# Dunkellin River and Aggard Stream Flood Relief Scheme

## Response to National Roads Authority

Client:	Galway County Council
Project Title:	Dunkellin River and Aggard Stream Flood Relief Scheme
Document Title:	Response to National Roads Authority
Document No:	MGE0260RP0021

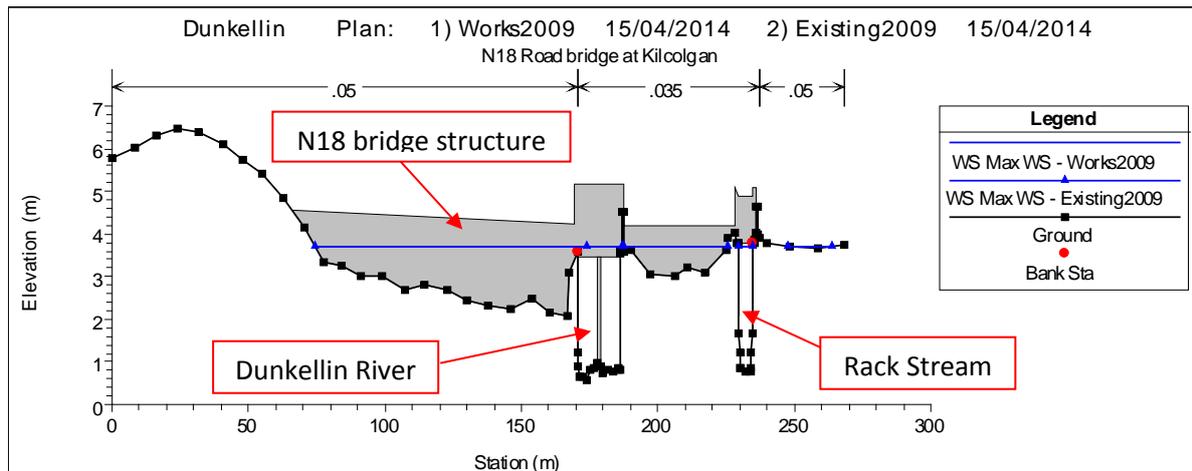
**1.1** *The information received by the Authority notes the N18 Bridge in Kilcolgan, however, the Authority advises that there is also a structure on the national road 50m north of the N18 Kilcolgan Bridge where the road crosses the Rack Stream, a tributary of the Dunkellin River which has been omitted from analysis. The Authority considers that this bridge requires consideration within the flood relief scheme and advises that the applicant needs to clearly demonstrate that there are no implications for the Rack Stream and hence the structure on the N18 at this location.*

The section of channel known as the Rack Stream was included in the hydraulic model used as part of the scheme’s development. The Rack Stream splits from the Dunkellin River approximately 160m upstream of the N18 Road Bridge and rejoins further downstream.

There are no proposed works on the Kilcolgan & N18 bridges; refer to Table 3-1 in the Works Description Report (Appendix A to the Main EIS).

An extract from the hydraulic model showing the N18 road bridges at Kilcolgan is given below. No perceptible change in water level or velocities is predicted by the works.
